# Access Compliance Report

## Public Rights-of-Way

### (Curb Ramps)

Intersection ID: 7505	Main Street: MERLANE_DR	Cross Street: W_SUGAR_CREEK_RD	Location: SW
ADA ID: 35DB9937C68B	Ramp Type: Para	Initial Pass/Fail: Fail	Overall Compliance: No
Severity Score: 13.75			
Codes/Mitigation Info/Possible Solution		Field Measurements/Component Compliance

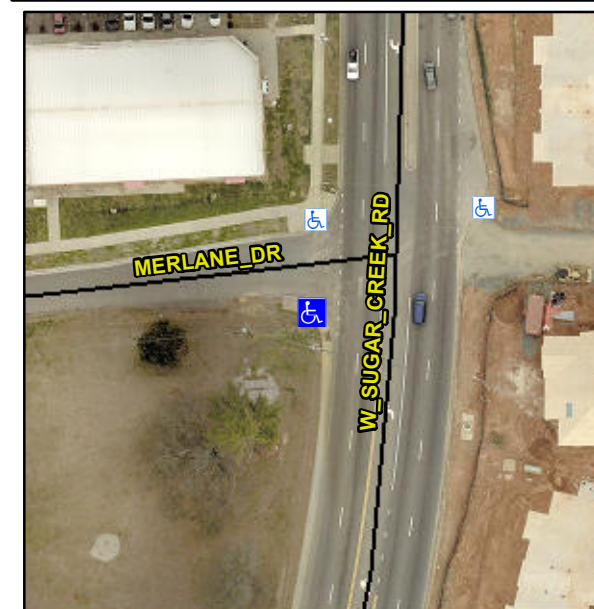
**R304.5.3, R304.3.2**

Compliance	Description	Data	Compliance	Description	Data
N/A	Ramp Length LT (in)	54.0	N/A	Ramp Length RT (in)	55.5
Yes	Ramp Width LT (in)	59.5	Yes	Ramp Width RT (in)	60.0
Yes	Ramp Slope LT (%)	5.8	No	Ramp Slope RT (%)	9.3
No	Ramp XSlope LT (%)	3.4	No	Ramp XSlope RT (%)	4.2
N/A	Landing Length (in)	N/A	N/A	DWS Provided?	N/A
N/A	Landing Width (in)	N/A	N/A	DWS Contrast?	N/A
N/A	Landing Slope (%)	N/A	N/A	DWS Length (in)	N/A
N/A	Landing X Slope (%)	N/A	N/A	DWS Full Width?	N/A
N/A	Landing Curb? (Y/N)	N/A	N/A	DWS Offset (in)	N/A
N/A	Shared Landing?	N/A			
N/A	Gutter Ponding?	N/A	N/A	Gutter Slope (%)	N/A
N/A	Gutter Lip Ht (in)	N/A	N/A	Gutter X Slope (%)	N/A
N/A	Painted X Walk1?	No	N/A	Painted X Walk2?	N/A
	X Walk 1 Direction	To N		X Walk 2 Direction	N/A
N/A	X Walk 1 Width (in)	N/A	N/A	X Walk 2 Width (in)	N/A
	X Walk 1 Slope (%)	0.9		X Walk 2 Slope (%)	N/A
	X Walk 1 X Slope (%)	0.7		X Walk 2 X Slope (%)	N/A
N/A	Ramp inside XWalk1?	N/A	N/A	Ramp inside XWalk2?	N/A

Road Slope (%)	N/A	N/A	Clear Space?	N/A
	Road X Slope (%)	N/A	N/A	Clear Space to XWalk (in)	N/A
N/A	Any Obstructions?	N/A	N/A	Storm Grate/Utility Hazard?	N/A
	Obstruction Type			Storm Grate/Utility Type	
		N/A			N/A
			Yes	Surface Condition? (G/P)	Good
			N/A	Curb Slope (%)	10.7

**Remove & Replace Entire Ramp.**
